Technical News Bulletin

Steinhausen, September 2010

Replacement of 555 Tube Height Jack

New Version Tube Height Jack
59-17502-2

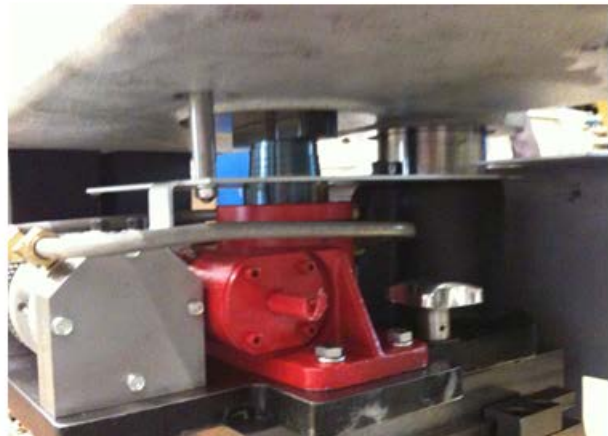
Owing to the obsolescence of commercial component as shown (Old Version tube height jack 59-17502-1), there has been a necessity to replace this with new version 59-17502-2. **Modifications are required to fit the new Component.** The new version of the jack has been used in production of 555 feeder tube height adjustment mechanisms from 3rd quarter of 2008 and is clearly identifiable with the silver color instead of the original red color.

The new jack 59-17502-2 requires a larger hole in the tube holder and the support plate it can not be replaced without the modifications to these parts prior to the modifications to the parts as shown on the attached drawings. There is also a conversion kit of parts 59-17502-3. This includes the new Jack screw and the required mounting parts as listed below.

- Old Version tube height jack 59-17502-1 should be replaced with new version 59-17502-2.
- The new version of the jack has been used in production of 555 feeder tube height adjustment mechanisms.
- Modifications are required to fit the new Component.

59-17502-1	Old version of jack RED
59-17502-2	New version of jack Silver
59-17502-3	Conversion of old to new jack including mounting parts - alteration is required
